RETREAT AT TIMBERRIDGE FILING NO. 3

COUNTY OF EL PASO, STATE OF COLORADO

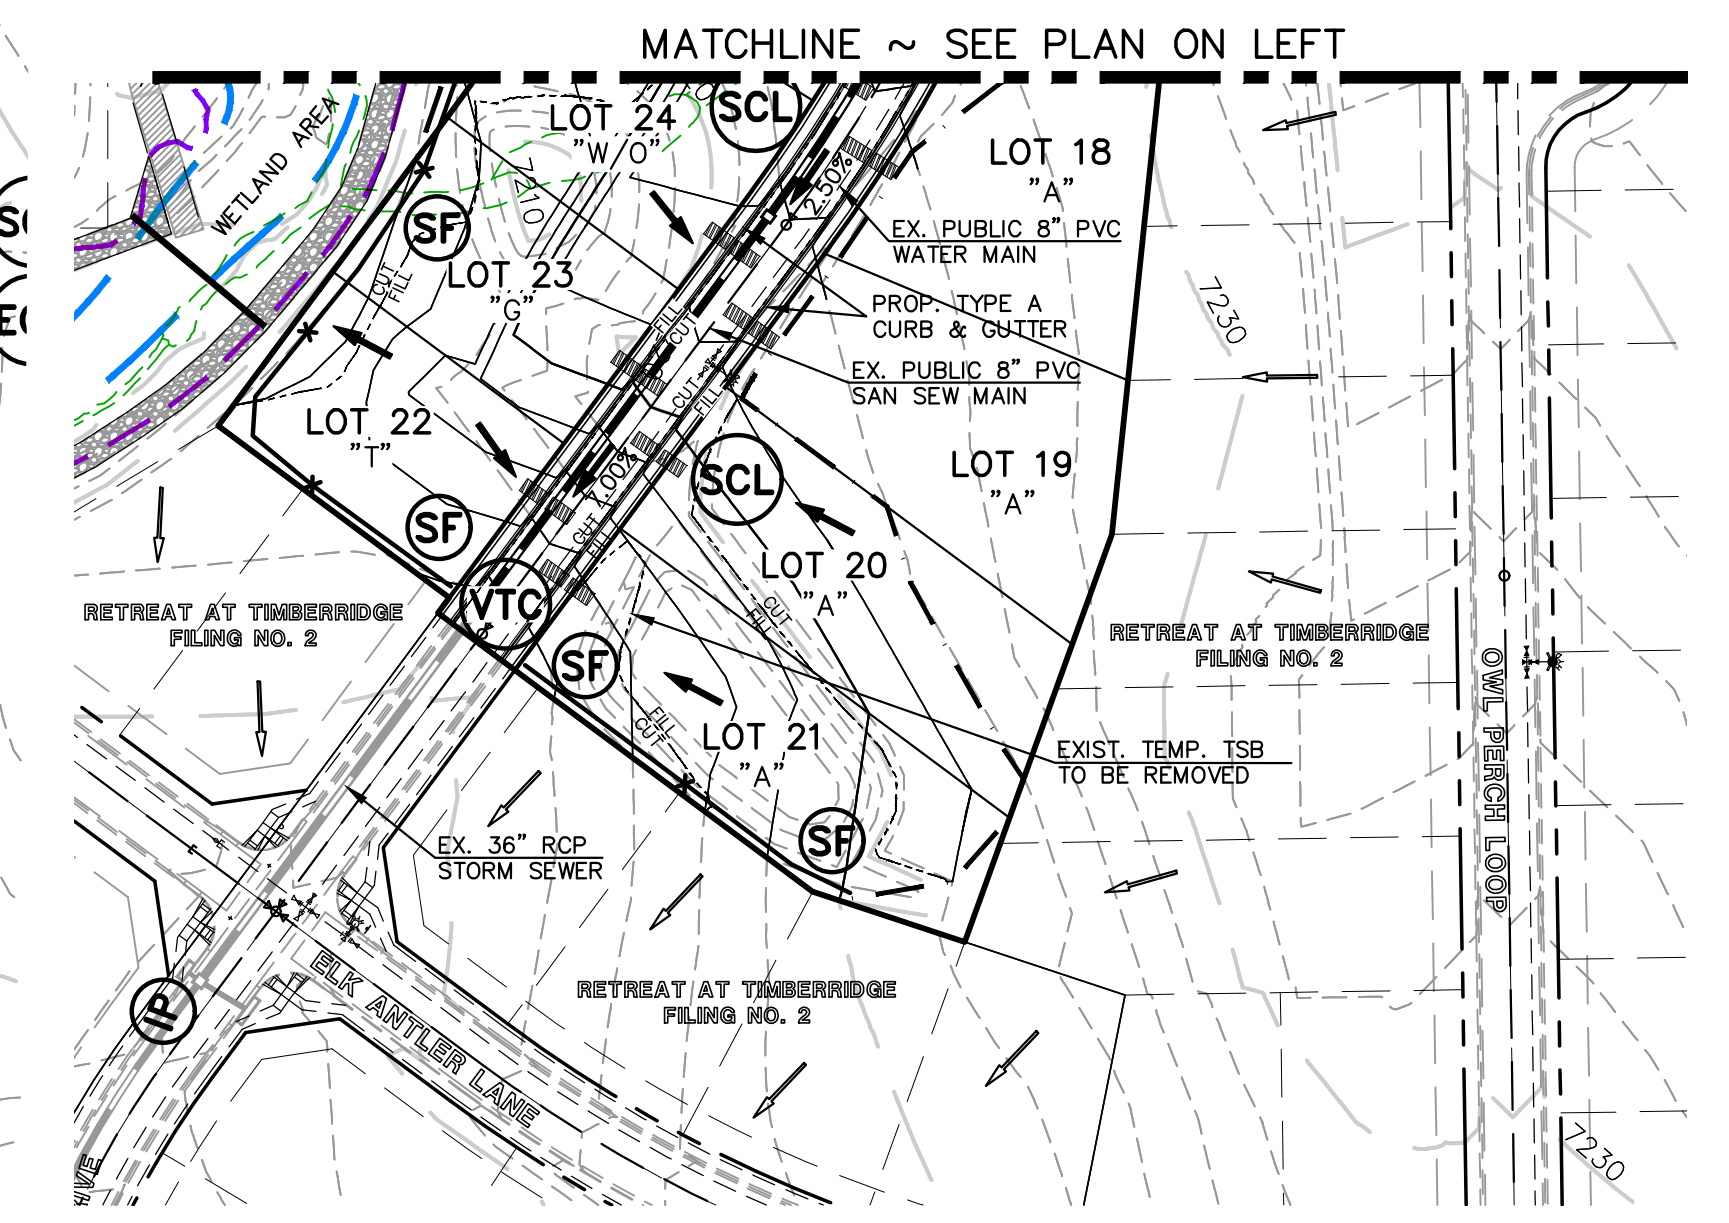
NO.	REVISION	DATE
1	REVISED PER EPC COMMENTS	9-21-23
2	REVISED PER EPC COMMENTS	10/30/23
3	REVISED PER ARROYA DESIGN CHANGE	1/31/24
4	REVISED PER COUNTY COMMENTS	3/4/24
5	REVISED PER COUNTY COMMENTS	4/18/24

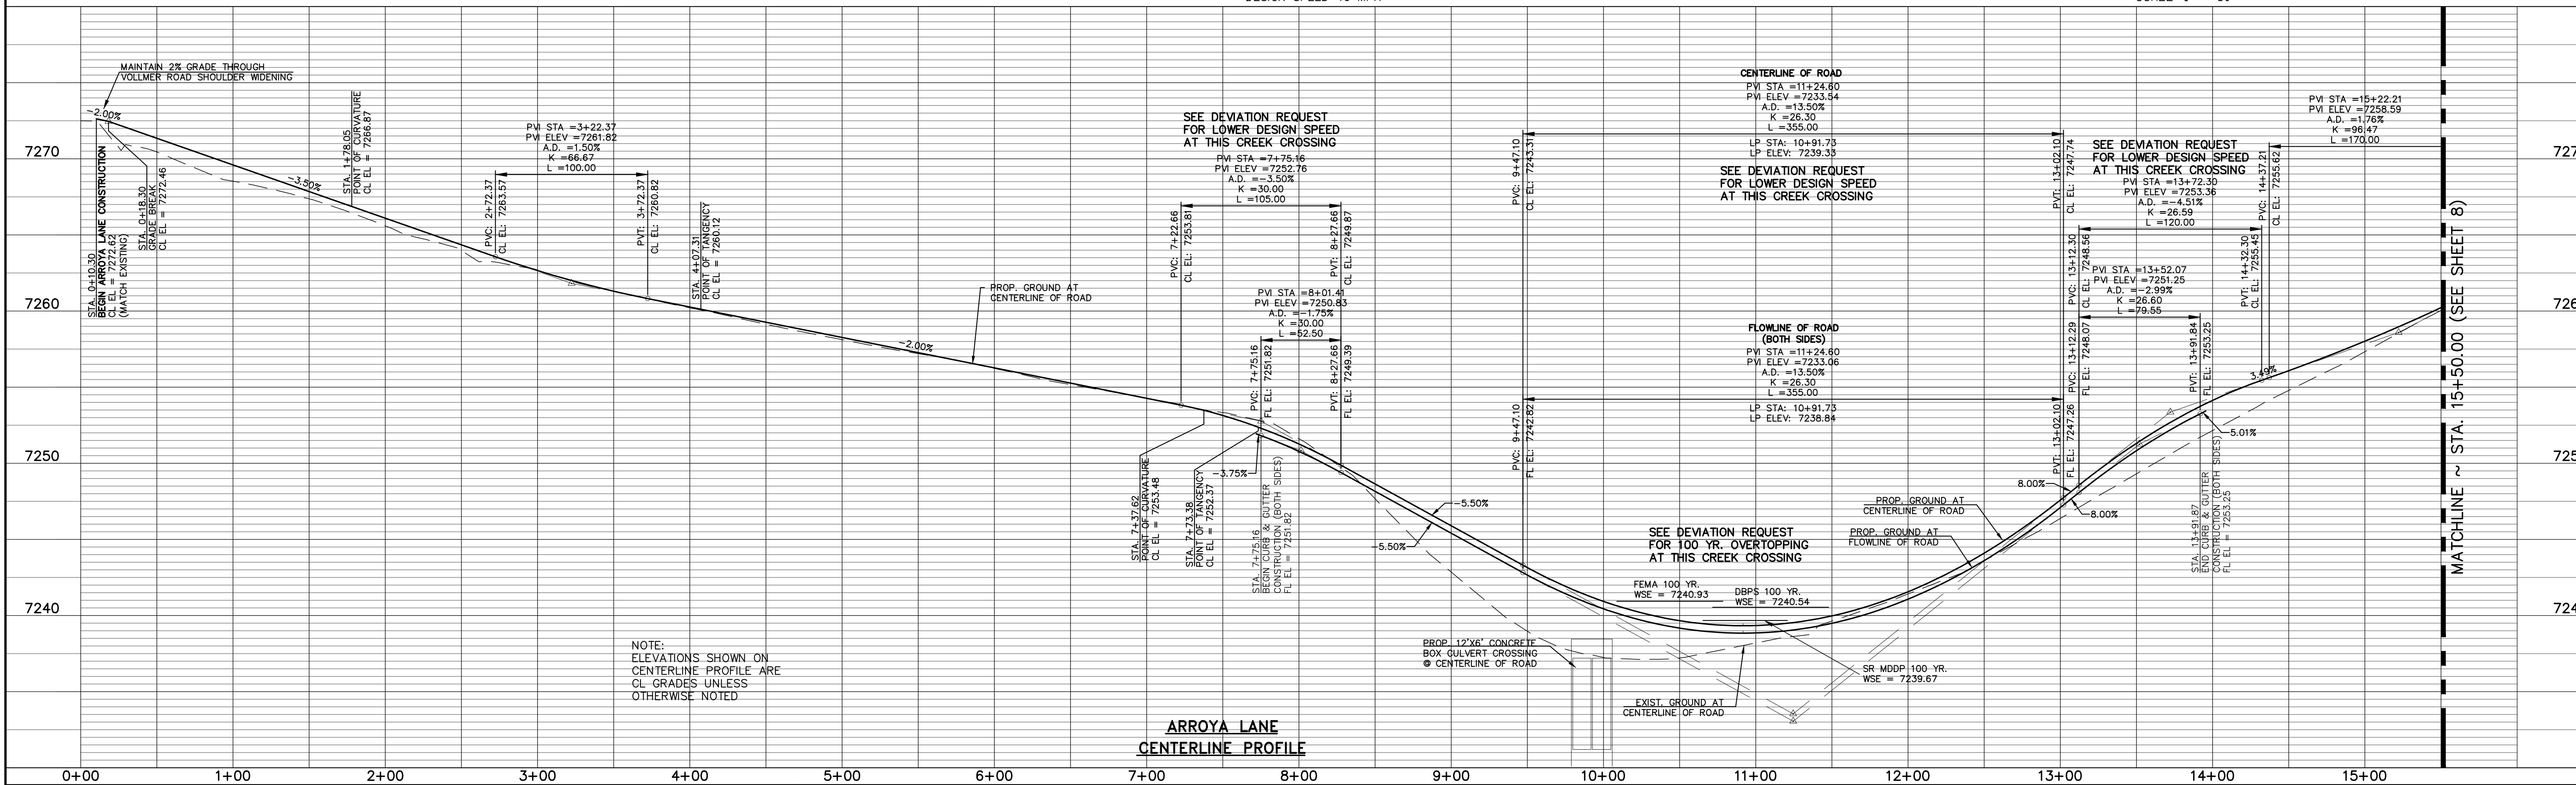
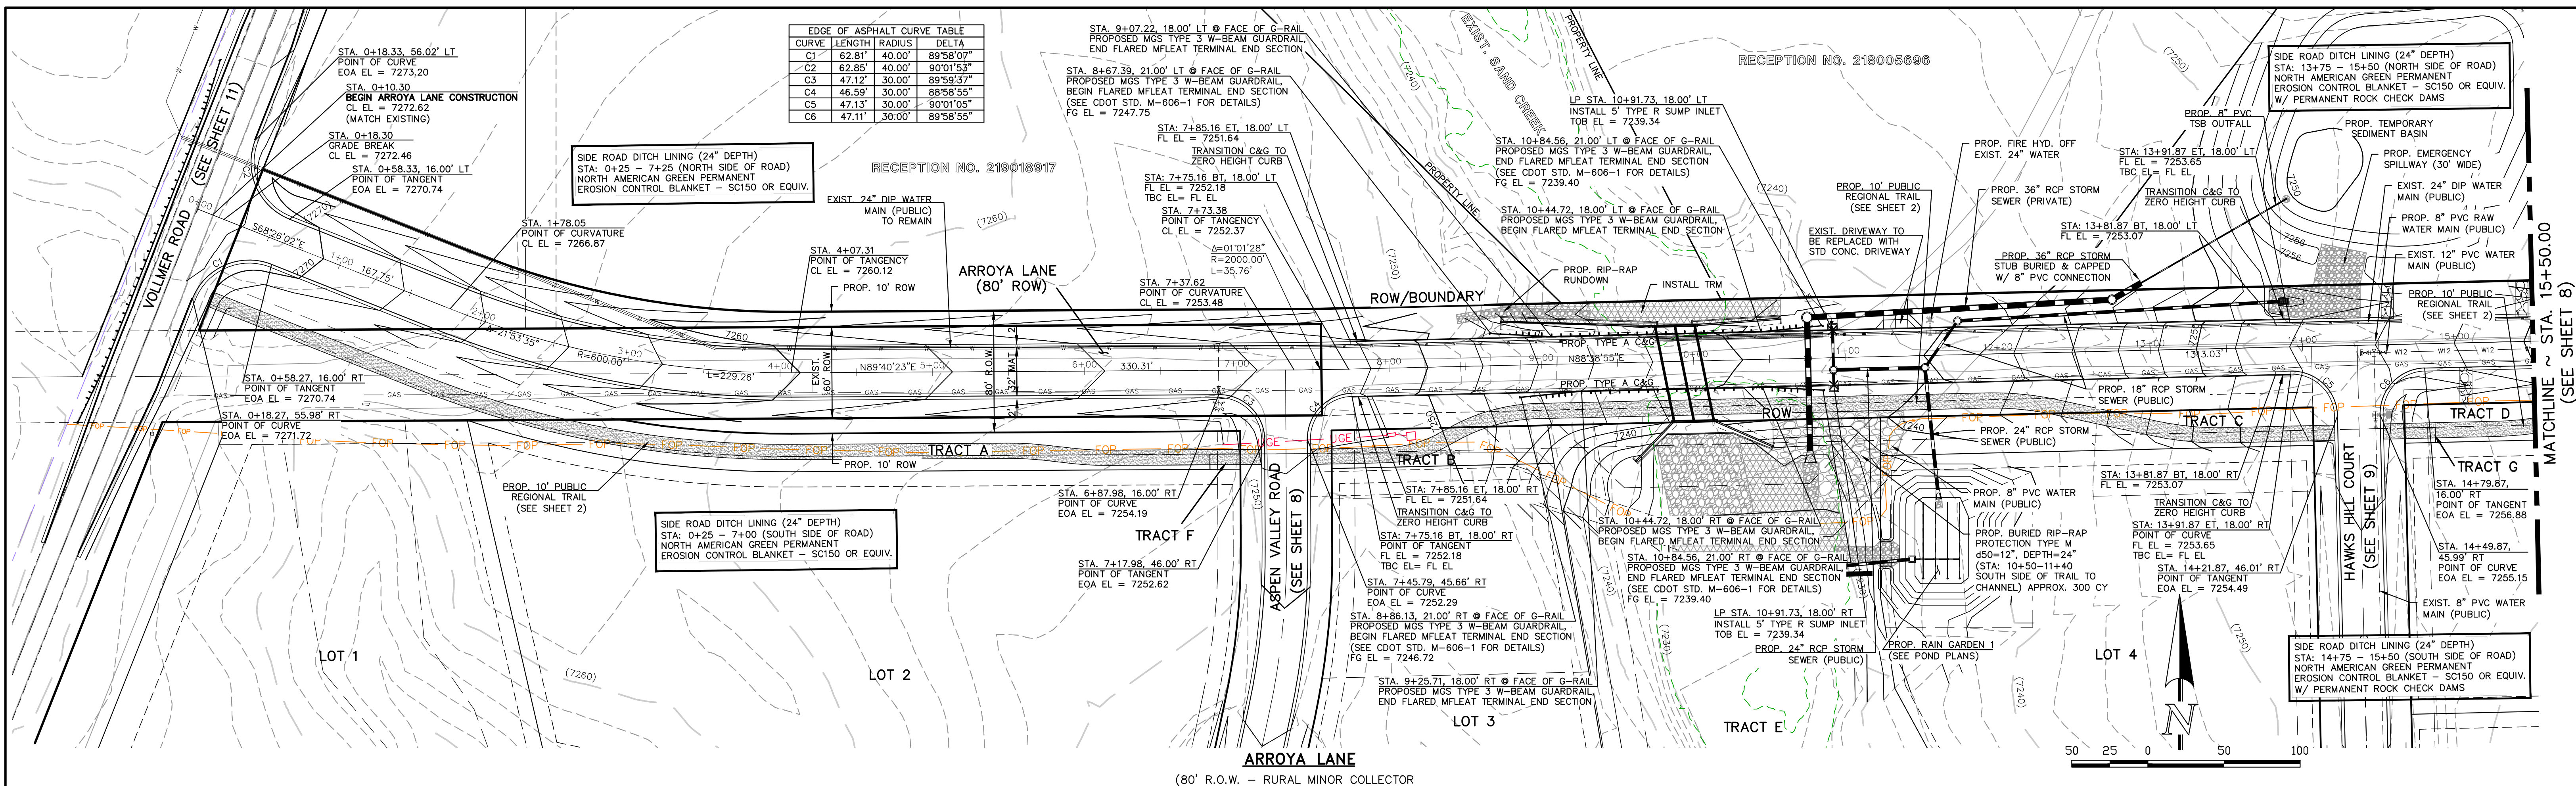
NO.	REVISION	DATE
1	REVISED PER EPC COMMENTS	3-07-23
2	REVISED PER COUNTY PARKS COMMENTS	12-6-23
3	REVISED ROAD GRADE PER CULVERT REVISION	1-30-24
4	REVISED PER COUNTY COMMENTS	3-14-24
5	REVISED PER COUNTY COMMENTS	4-18-24

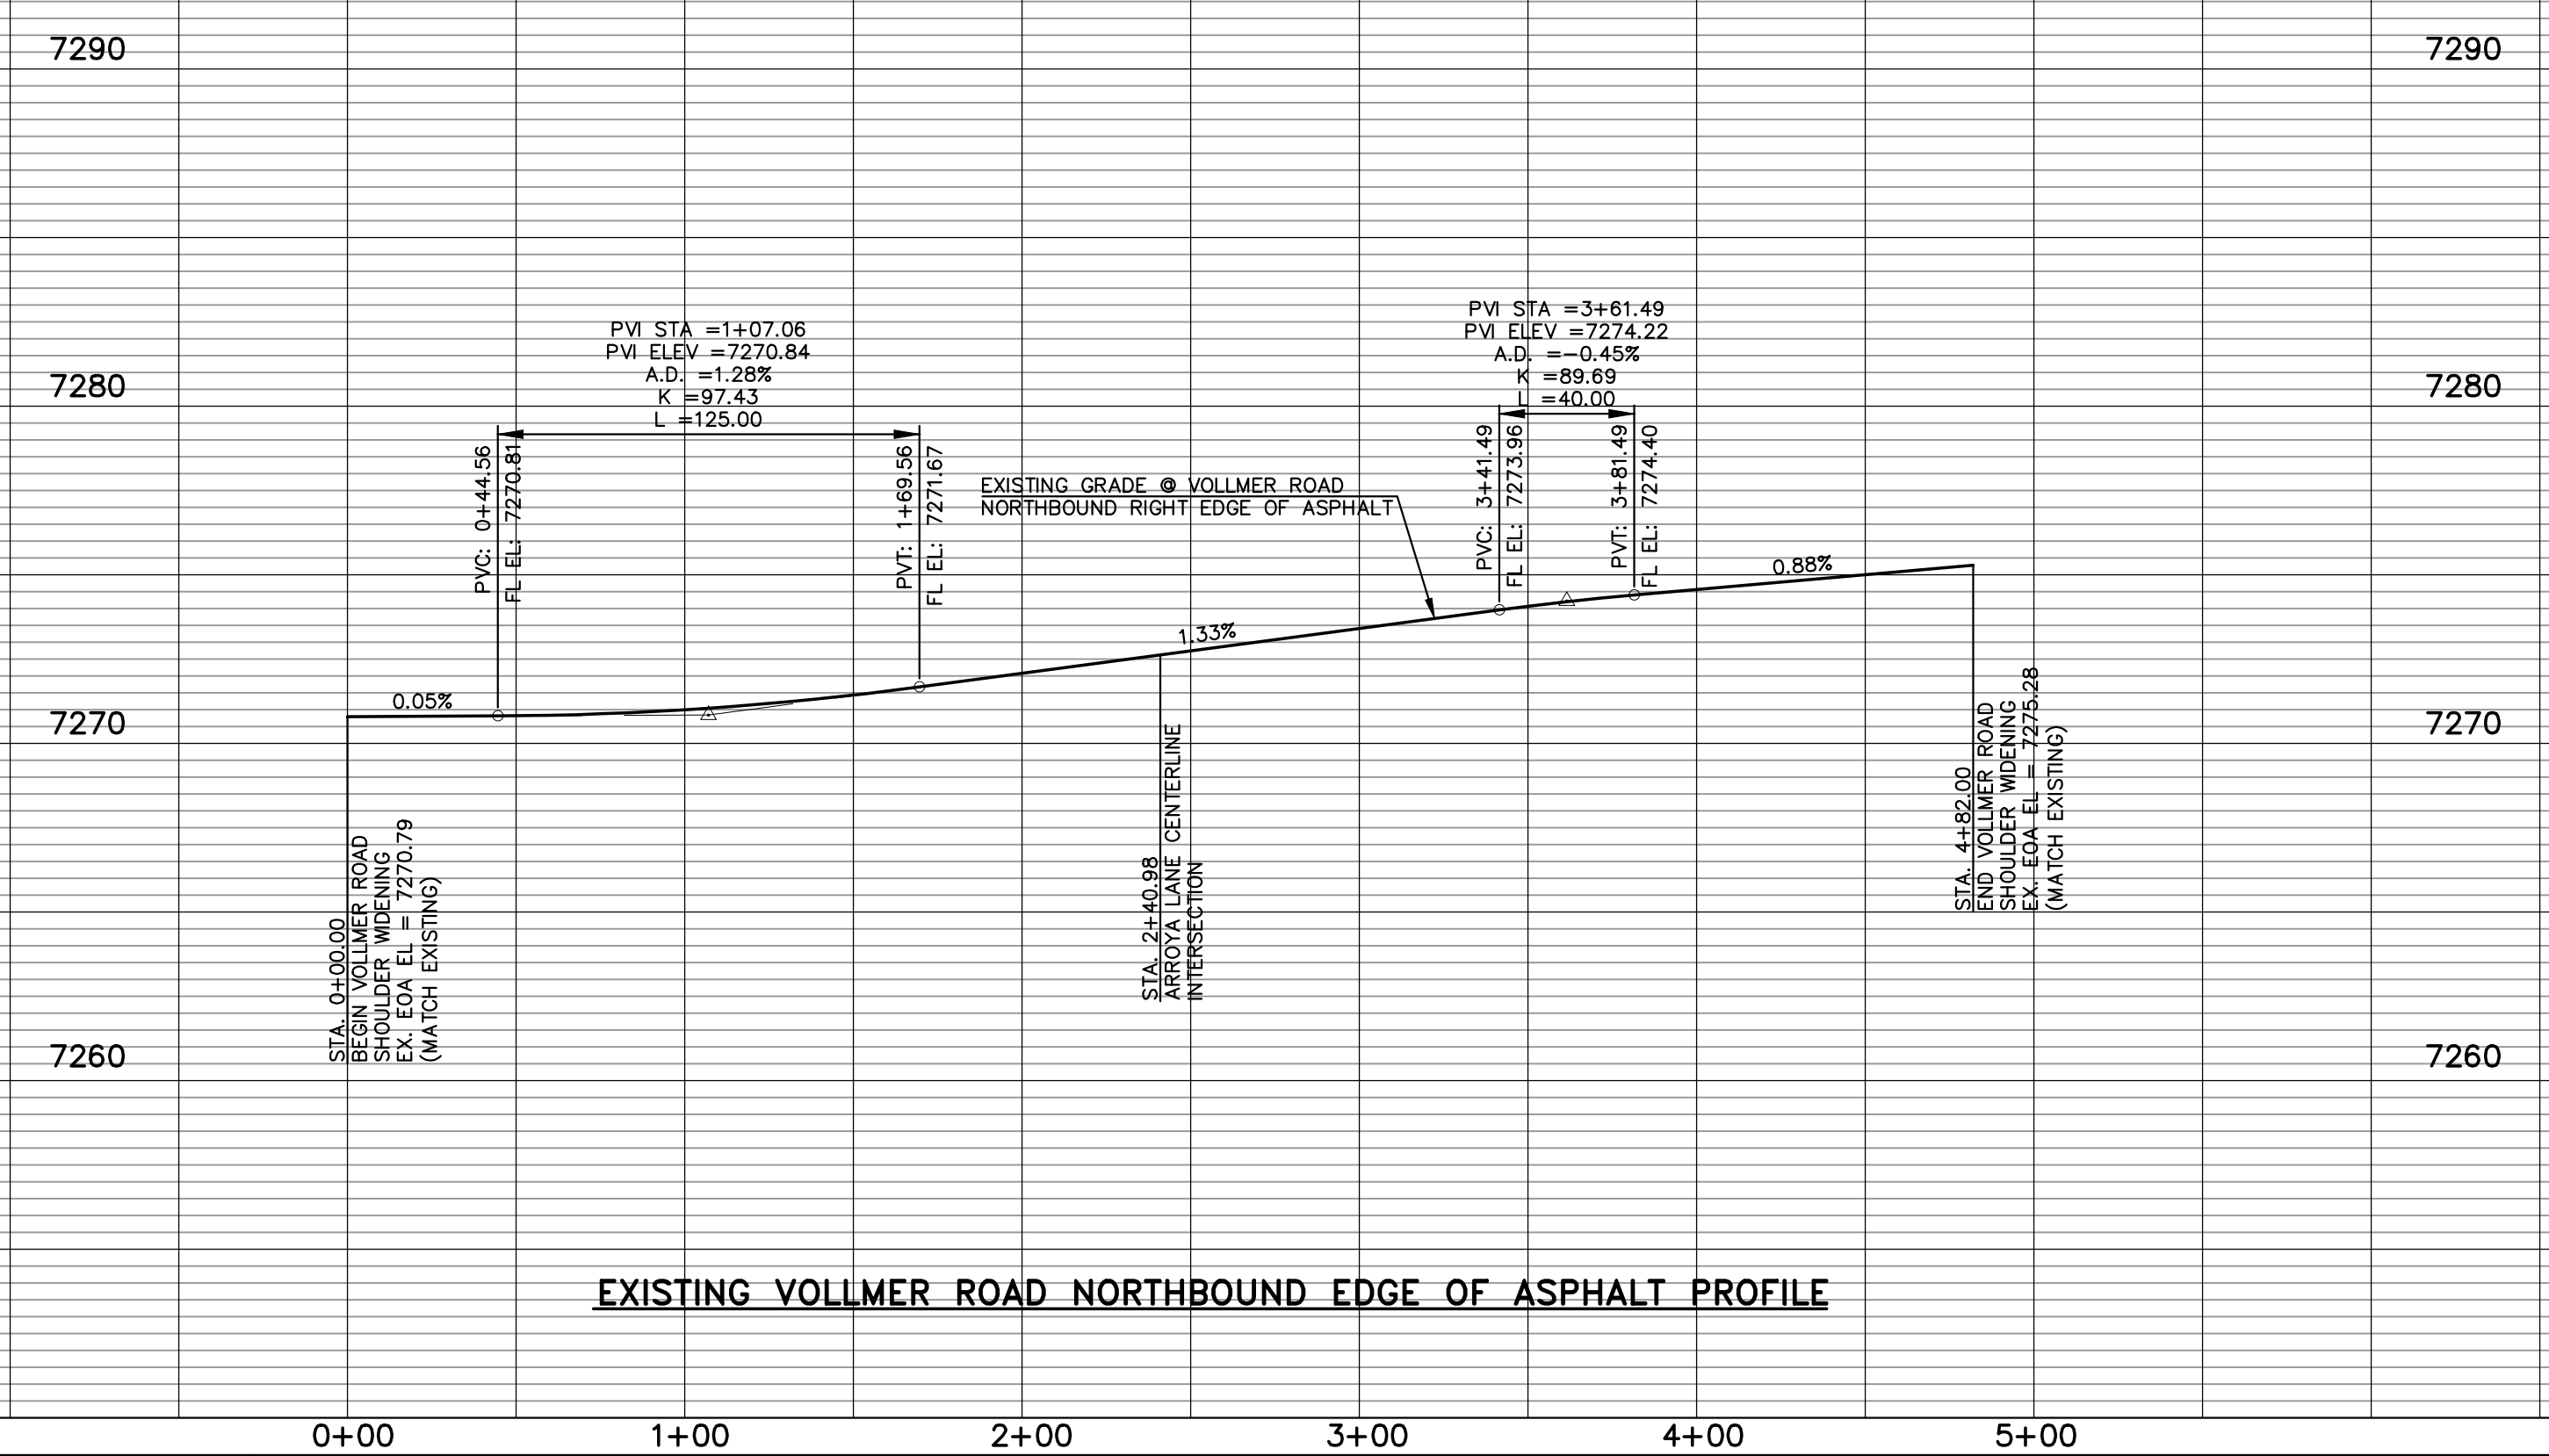
<p>48 HOURS BEFORE YOU DIG, CALL UTILITY LOCATORS 811 UTILITY NOTIFICATION CENTER OF COLORADO IT'S THE LAW</p> <p>THE LOCATIONS OF EXISTING UNDERGROUND UTILITIES ARE SHOWN IN AN APPROXIMATE WAY ONLY. THE CONTRACTOR SHALL DETERMINE THE EXACT LOCATION OF ALL EXISTING UTILITIES BEFORE COMMENCING WORK. THE CONTRACTOR SHALL BE FULLY RESPONSIBLE FOR ANY AND ALL DAMAGES WHICH MIGHT BE CAUSED BY HIS FAILURE TO EXACTLY LOCATE AND PRESERVE ANY AND ALL UNDERGROUND UTILITIES.</p>	<p>NO. REVISION</p> <table border="1"> <tr> <td>1</td> <td>REVISED PER EPC COMMENTS</td> <td>3-07-23</td> </tr> <tr> <td>2</td> <td>REVISED PER EPC COMMENTS</td> <td>10/31/23</td> </tr> </table>	1	REVISED PER EPC COMMENTS	3-07-23	2	REVISED PER EPC COMMENTS	10/31/23	<p>REVIEW:</p> <p>PREPARED UNDER MY DIRECT SUPERVISION FOR AND ON BEHALF OF CLASSIC CONSULTING AND SURVEYORS, LLC</p> <p>MARC A. WHORTON #37155</p>	<p>DATE: 2/2/2024</p>	<p>RETREAT AT TIMBERRIDGE FILING NO. 3 CONSTRUCTION PLANS STREET IMPROVEMENT PLANS VOLLMER ROAD EAST SHOULDER WIDENING</p> <p>DESIGNED BY: PRA DRAWN BY: PRA CHECKED BY:</p> <p>SCALE: (H) 1" = 50' (V) 1" = 5'</p> <p>DATE: 11-22-2022 SHEET: 11 OF 27 JOB NO.: 1185.30</p>	<p>619 N. Cascade Avenue, Suite 200 Colorado Springs, Colorado 80903 (719) 785-0790 (719) 785-0799 (Fax)</p>
	1	REVISED PER EPC COMMENTS	3-07-23								
2	REVISED PER EPC COMMENTS	10/31/23									
<p>CLASSIC CONSULTING</p>
